# **Proposed reference equalizer change in Clause 124.**

Comment r01-21 supporting material

May 2017, New Orleans, LA, USA

# Comment r01-21 against IEEE P802.3bs D3.1.

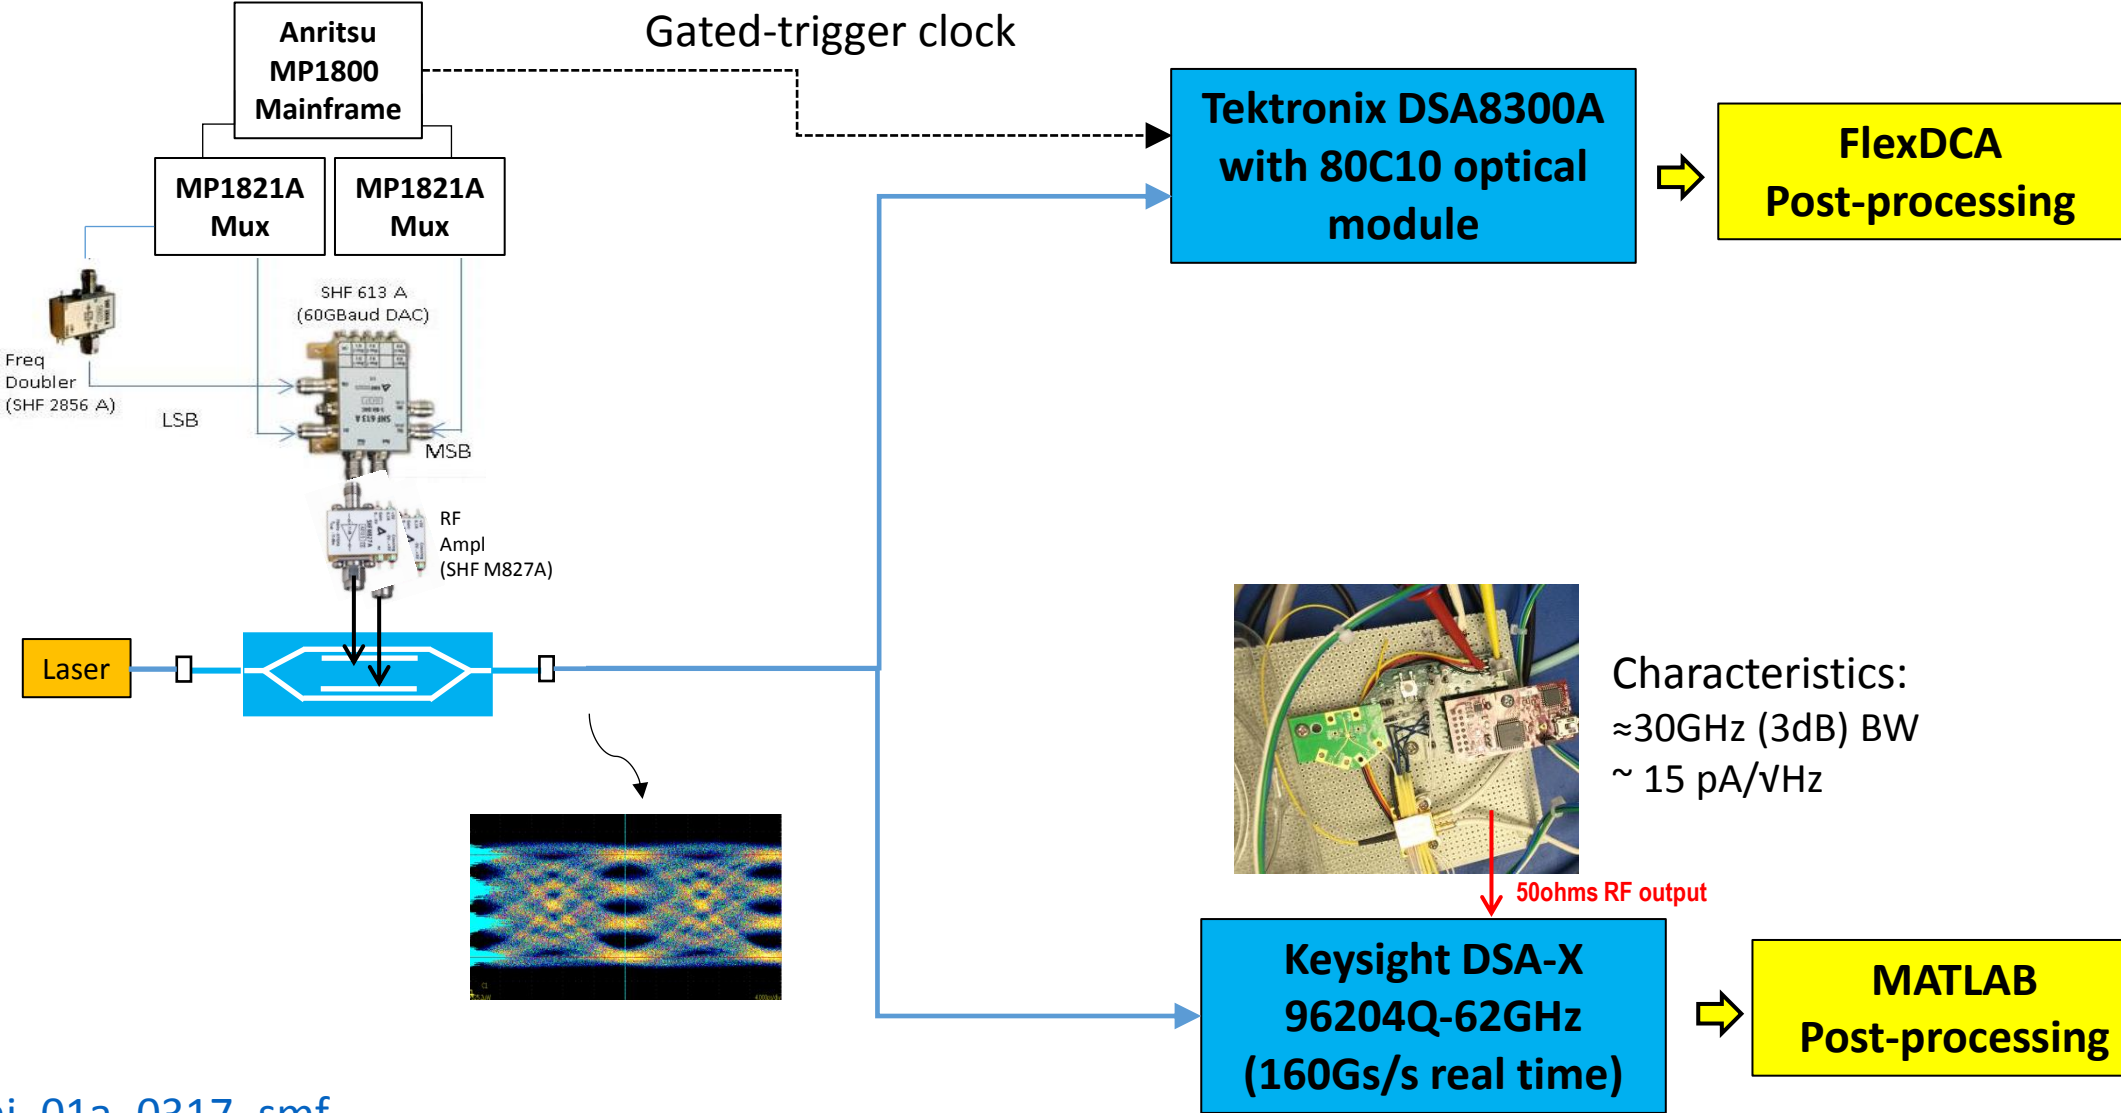
**Change from:** The TDECQ of each lane shall be within the limits given in Table 124-6 if measured using the methods specified in 121.8.5.1, 121.8.5.2, and 121.8.5.3 using a reference equalizer as described in 121.8.5.4, with the following exceptions:

- The signaling rate of the test pattern generator is as given in Table 124-6.
- The combination of the O/E converter and the oscilloscope has a fourth-order Bessel-Thomson filter response with a bandwidth of 38.68 GHz.

**Change to:** The TDECQ of each lane shall be within the limits given in Table 124-6 if measured using the methods specified in 121.8.5.1, 121.8.5.2, and 121.8.5.3 with the following exceptions:

- The signaling rate of the test pattern generator is as given in Table 124-6.
- The combination of the O/E converter and the oscilloscope has a fourth-order Bessel-Thomson filter response with a bandwidth of 38.68 GHz.
- The reference equalizer is a 5 tap, T spaced, feed-forward equalizer (FFE), where T is the symbol period.

NOTE-This reference equalizer is part of the TDECQ test and does not imply any particular receiver equalizer implementation
